BOLTON PLANNING & ZONING COMMISSION
Regular Meeting
7:30 p.m., Wednesday, October 12, 2022
Virtual
Minutes & Motions

b. Modification of Special Permit Application for Gas Station/Convenience Store, 271 Hop River Road, Nathaniel Fleming (#PL-22-8)

Re: Planning & Zoning Commission – 271 Hop River Road

SHEET NO. 5 OF 11	JOB NO. 21-000985	DRAWN BY: CAC
-------------------	-------------------	---------------

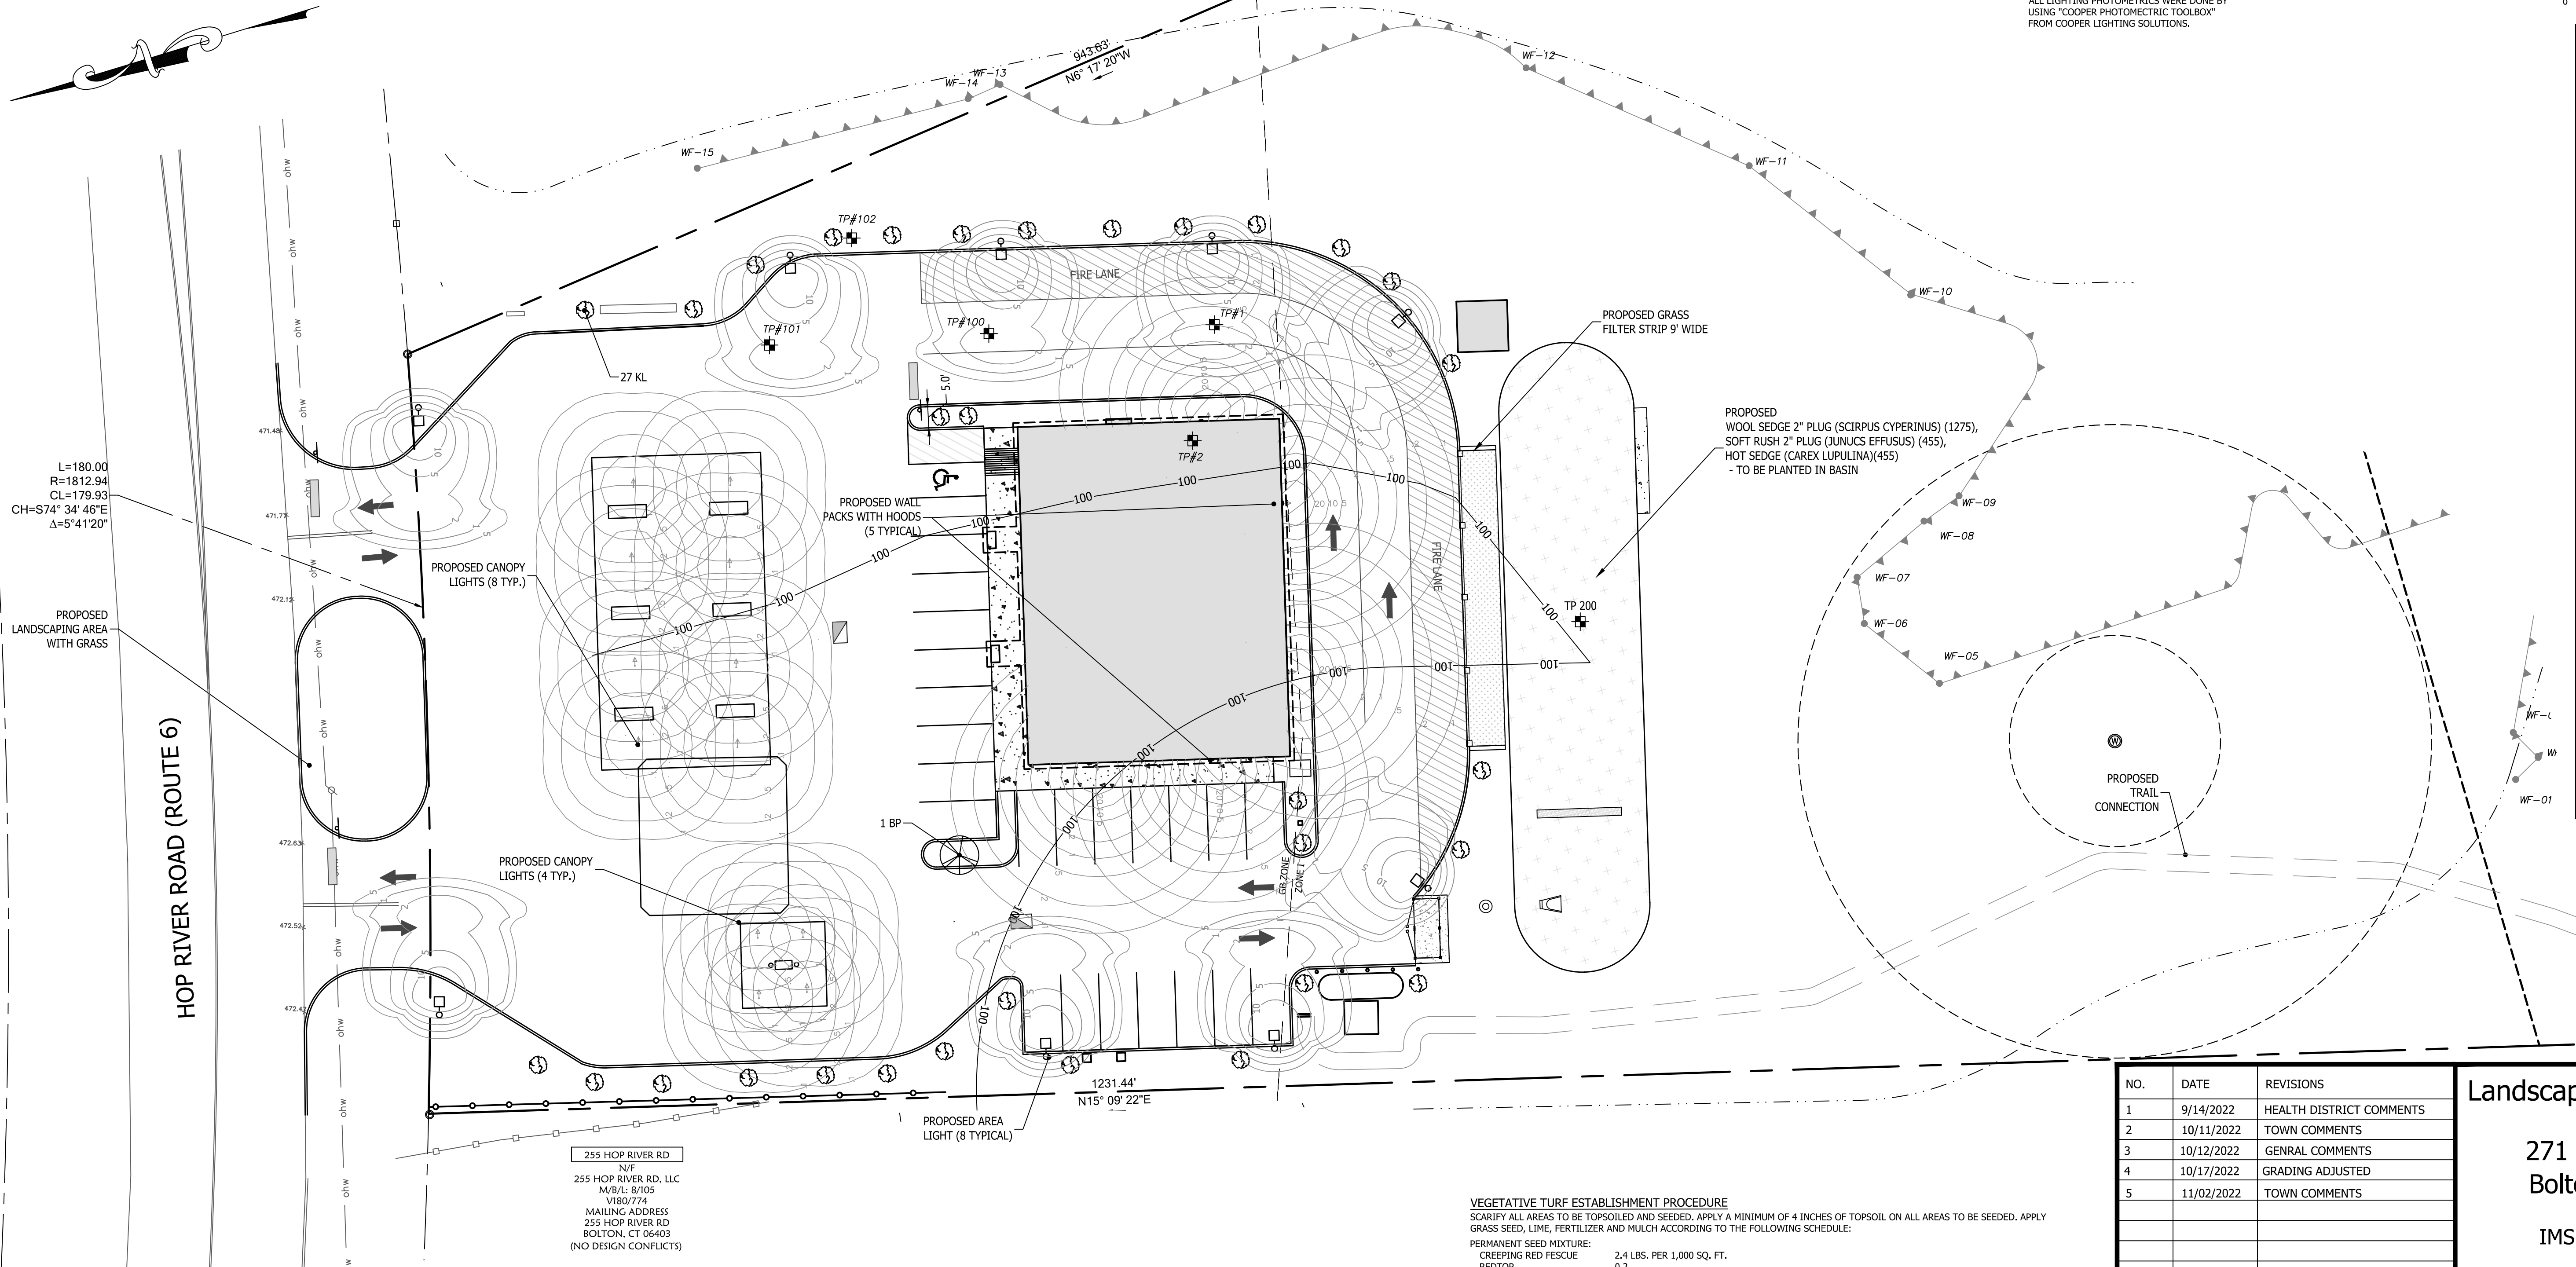
7. The two pole lights at the entrance/exits of the site and the “Proposed Sign Light” on the east property line appear to cast light to the adjacent property. Beyond the regulations prohibiting this, staff questions if there is perhaps a better location for these lights, so they are not located essentially on the property line. The “proposed sign light” is not allowed. – **Addressed during the meeting (10/12/2022).**

10. The lighting plan shows two wall pack fixtures – one with a hood which is allowed, and one without a hood which is not allowed and should be removed from the lighting detail. – **Addressed.**
